# **FREDERICK COUNTY PLANNING COMMISSION**

**TITLE:** **Wendy's at Westview South MXD  
(Saul Center)**

**FILE NUMBER:** **SP-98-36, AP #18976,  
APFO #18977, FRO #18978**

**REQUEST:** **Site Development Plan**

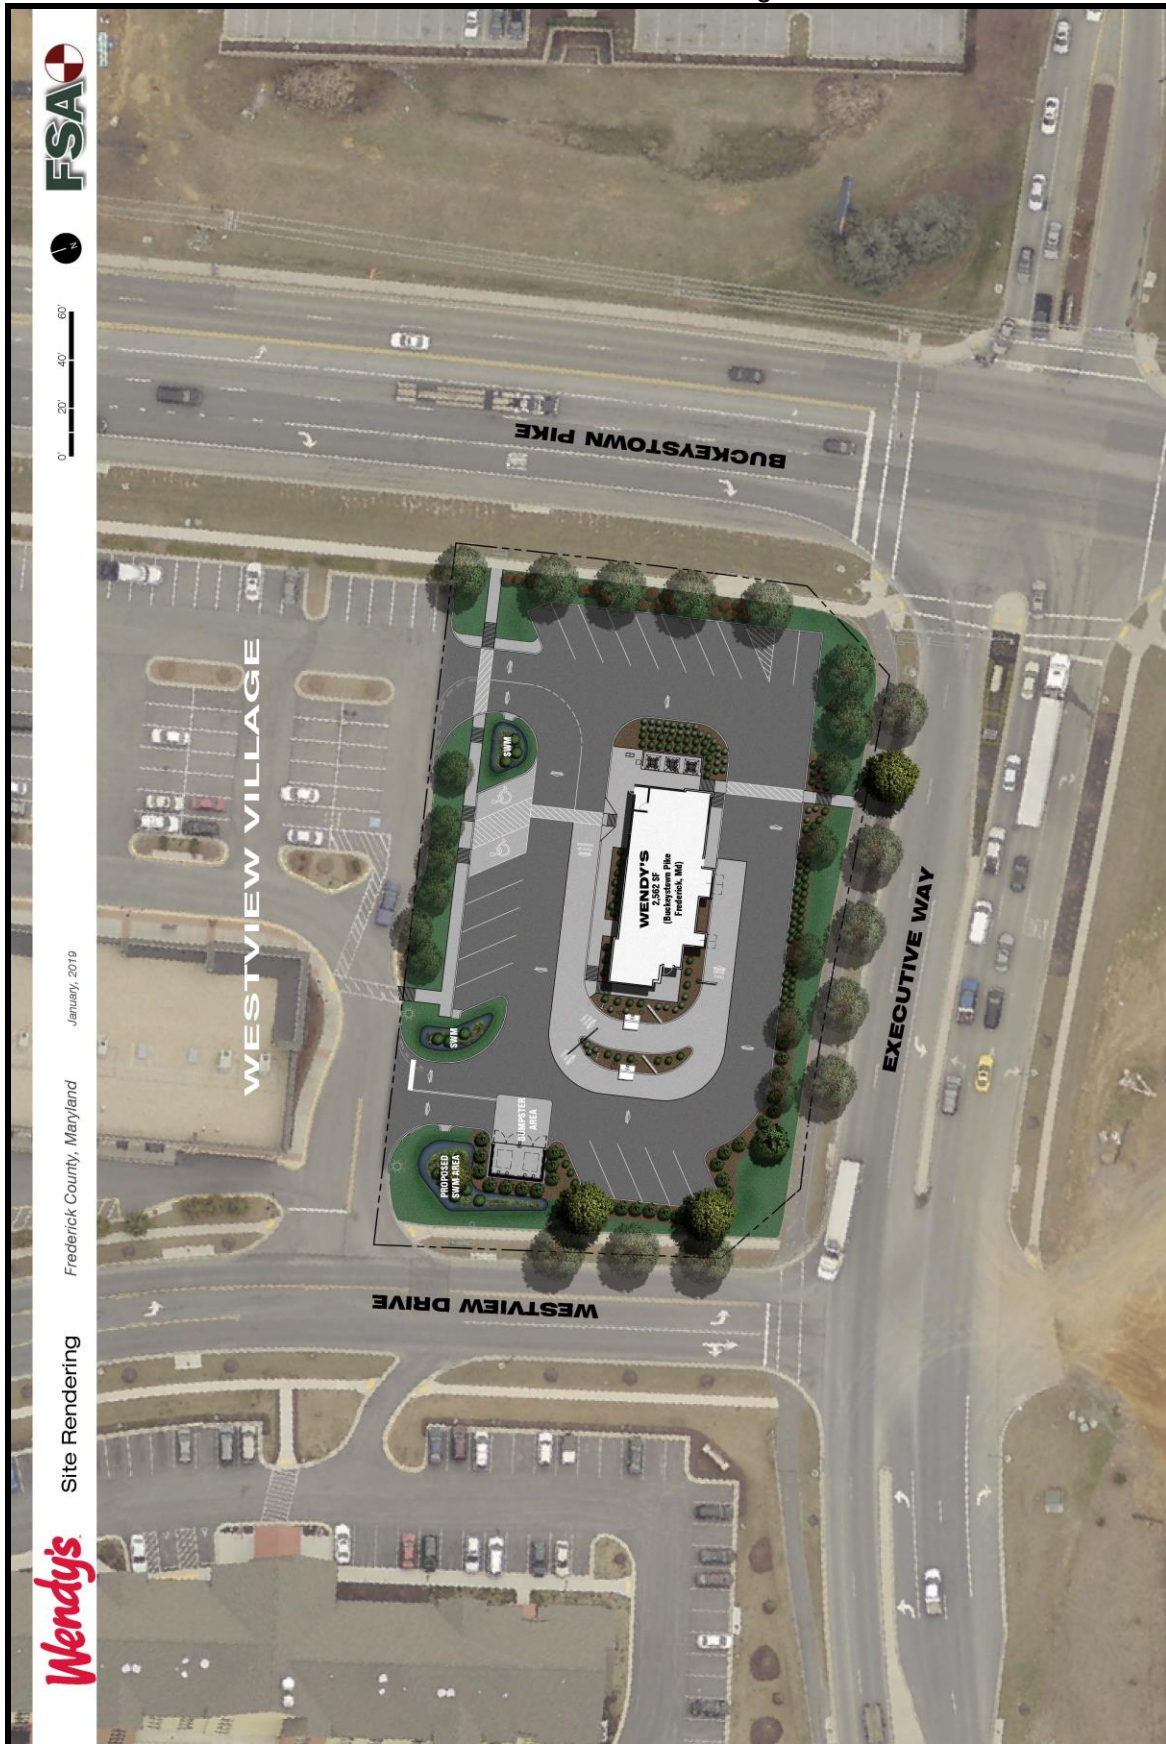
1. Planning Commission approval of a lighting modification to allow levels of illumination to exceed 0.5 fc at three areas along the northern, eastern, and southern Site boundaries as demonstrated on the photometric plan.
